CITY OF SMYRNA COMMUNITY DEVELOPMENT DEPARTMENT MEMORANDUM

RE: ANNEXATION AND REZONING CASE Z17-014 – 2800 & 2810 Spring Road

Development of a mixed use development consisting of a hotel, office building, retail building and an apartment building.

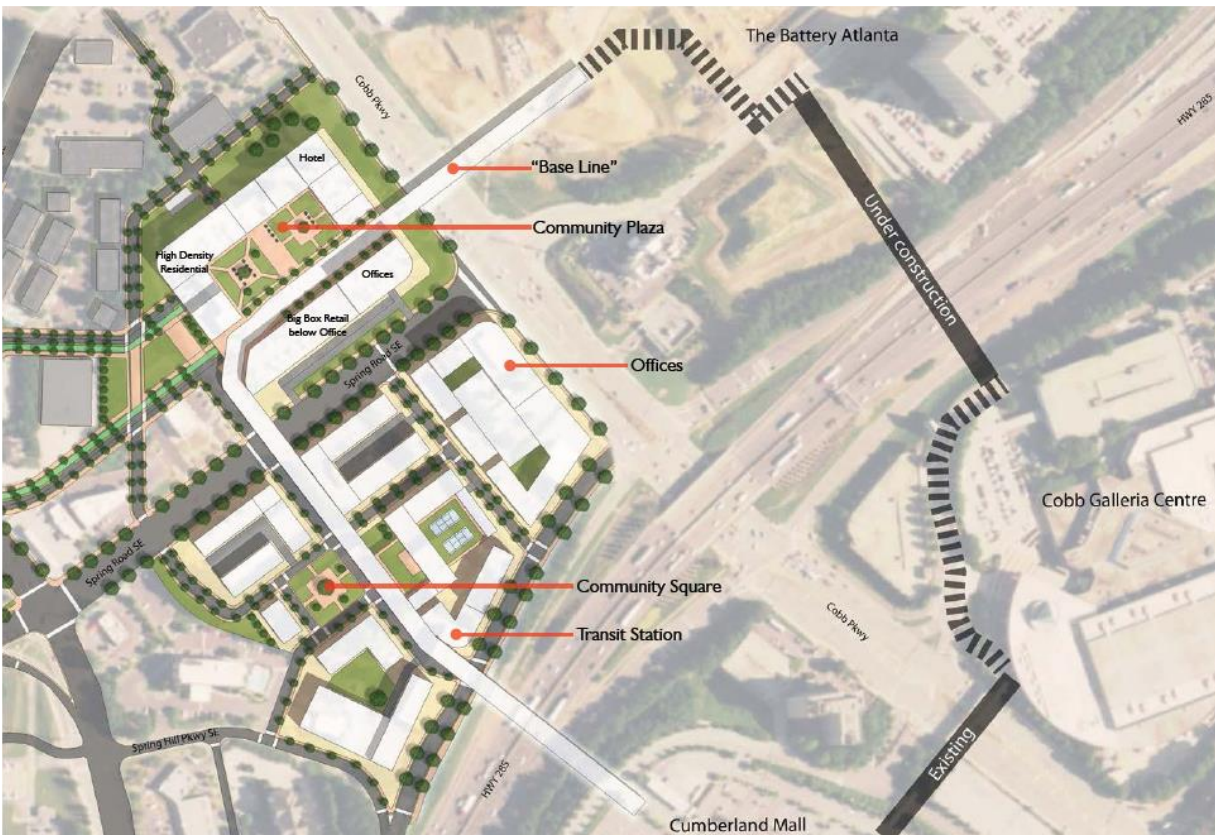
The City's Fire Marshal's Office has reviewed the proposed plan and believes that in the current design they cannot adequately serve this development. The Fire Marshal's Office has provide the following items that need to be addressed with respect to the site plan to provide appropriate emergency response and access:

1. All entrances must be a minimum 26' in width from back of curb to back of curb (BOC);
2. All private roads through the development must be increased to 26' width (BOC);
3. All private roads shall be constructed to city standards;
4. All radii within the development shall be a minimum of 25';
5. The emergency lane around the multi-family building shall be paved;
6. The drive aisle around the retail building shall be a minimum of 20';
7. A 26' paved access lane shall be provided around the office building;
8. The perpendicular parking between the hotel and retail building on main access road presents accessibility issues;
9. The five parking space near the first right-in/right-out entrance shall be removed; and
10. There is no parking or accessibility design for the office building.

This development will need to address all the issues described above and meet all the city requirements with regards to the fire code.
